Jordan Springs East (JSE), Penrith

1. Further to your request, you have asked the writers for a joint answer to the question “Is the fill at Jordan Springs East Development controlled fill or uncontrolled fill?”
2. We confirm that we are aware of the instructions of the Expert Witness Code of Conduct, Uniform Civil Procedure Rules (UCPR) in Part 31 Division 2, and the Expert Witness Code of Conduct, Schedule 7 of the UCPR, and that these have been read and understood. The writers are specialists in the field of geotechnical engineering, with particular expertise in unsaturated soil mechanics.
3. The following is given:

Figure 13: Area within Stage EW 6.2, and approximately centred by Lot 3032 where compaction test results were examined

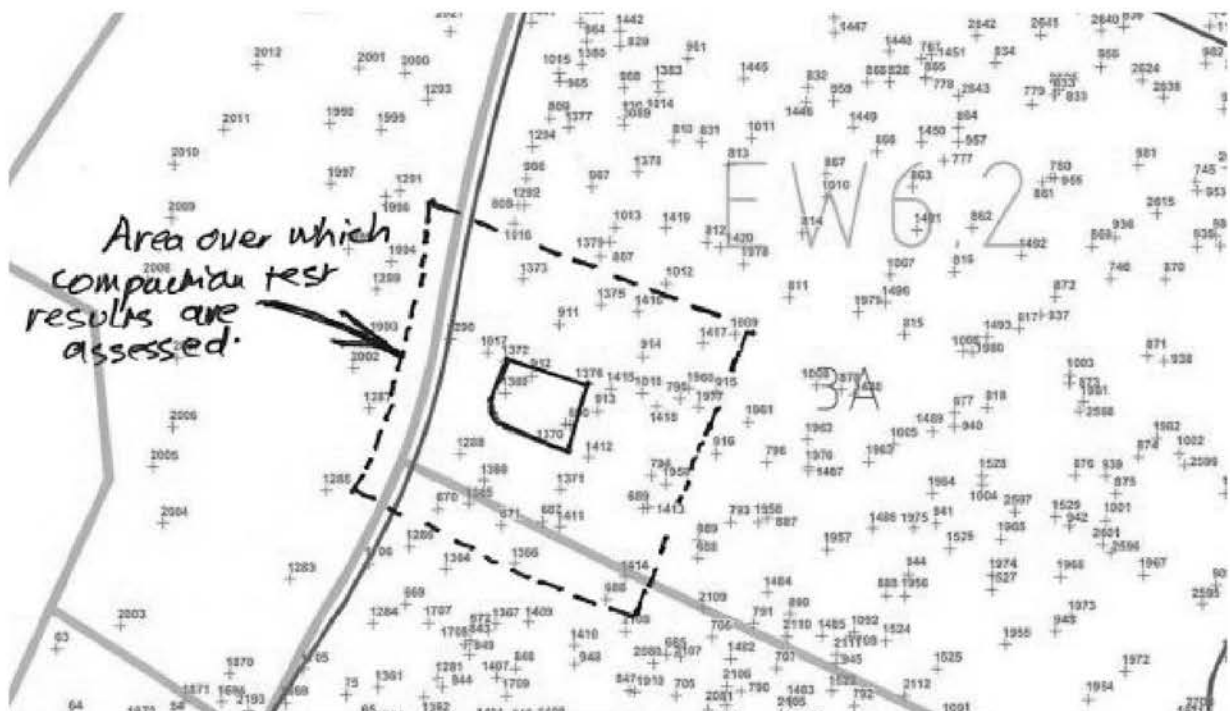
89. Lot 3032 is located within Stage EW6.2, as shown in Figure 13. Figure 13 also shows the locations of compaction tests (from Reference m) in the vicinity of Lot 3032.
90. In Reference (bb), PSM have indicated that the site contains about 4 m depth of fill. This depth of fill is consistent with that indicated in Reference (m).
91. It is understood from Reference (m), that the final ground surface at Lot 3032 is about RL 22.2 m.
92. Within an area of about 6,000 m², approximately centred by Lot 3032 as shown in Figure 13, the writers have determined from Reference (m), the compaction test result at every location tested.
93. For each test location, the value of measured density ratio and the Reduced Level (RL) of the test were determined. A total of 39 tests was carried out, which were all examined.
94. The results are shown in Figure 14 as a graph of density ratio with RL.

Figure 14: Density Ratio vs RL for all tests within area shown in Figure 13

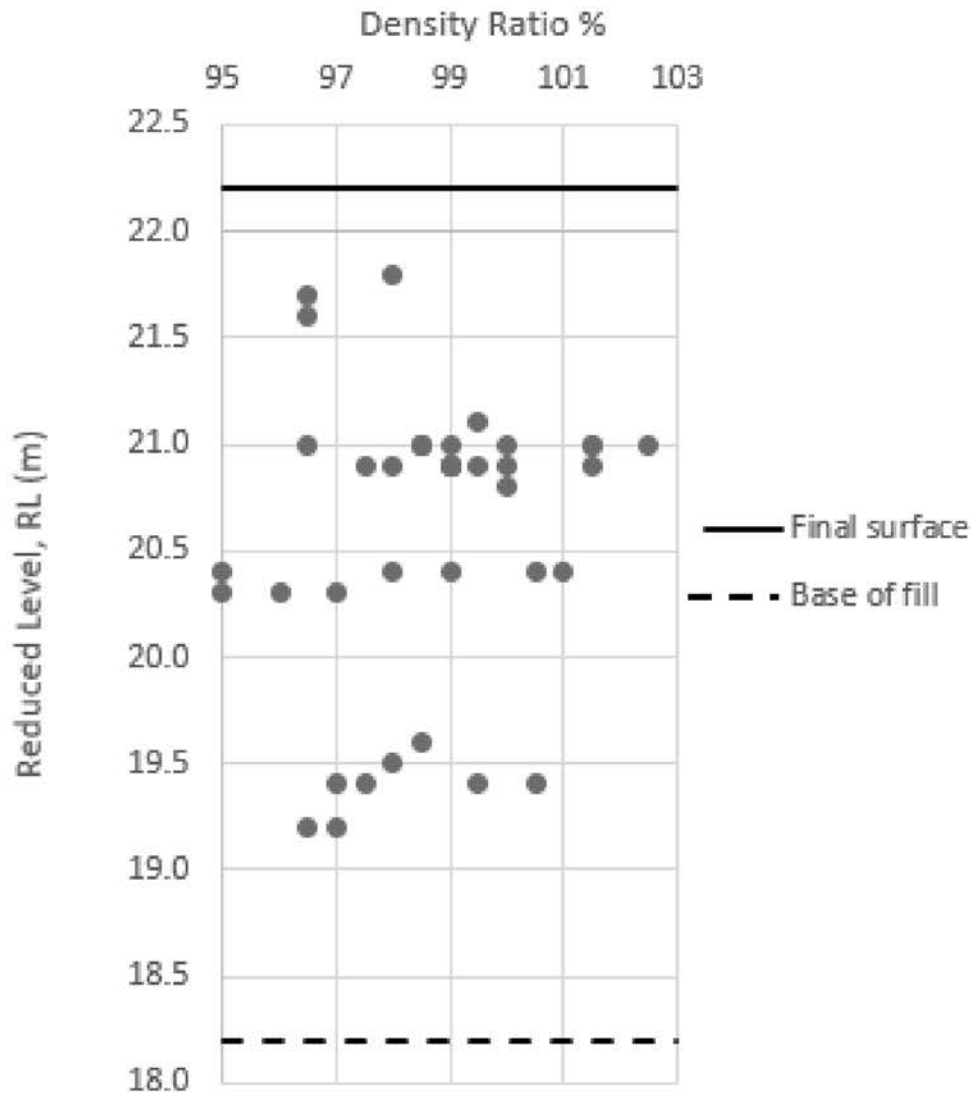
95. Several conclusions are made from Figure 14 as follows:

- For a 4 m depth of fill and the ground surface at RL 22.2 m, the base of the fill will be at about RL 18.2 m. No tests have been conducted in the lower 1 m of fill. By the Douglas Partners specification of 1 test per layer per 1500 m², for a compacted layer thickness of 250 mm, the number of tests required over the 6,000 m² area for this lower 1 m depth of fill is $(6000/1500) \times (1000/250) = 16$ tests rather than no tests, and
- No tests are reported for the approximate 700 mm thickness of fill from about RL 19.6 m to about RL 20.3 m. By the Douglas Partners specification of 1 test per layer per 1500 m² and a compacted layer thickness of 250 mm, the number of tests required over the 6,000 m² area for this lower 700 mm depth of fill is $(6000/1500) \times (700/250) \approx 11$ tests rather than no tests.

96. It is concluded from Figure 14 that the earthworks, at least in parts of the area of Lot 3044, had testing not meeting the requirements of the earthwork's specification, and so the earthworks, in sections, had insufficient control during construction, so that the quality of the fill, in parts, is uncertain.
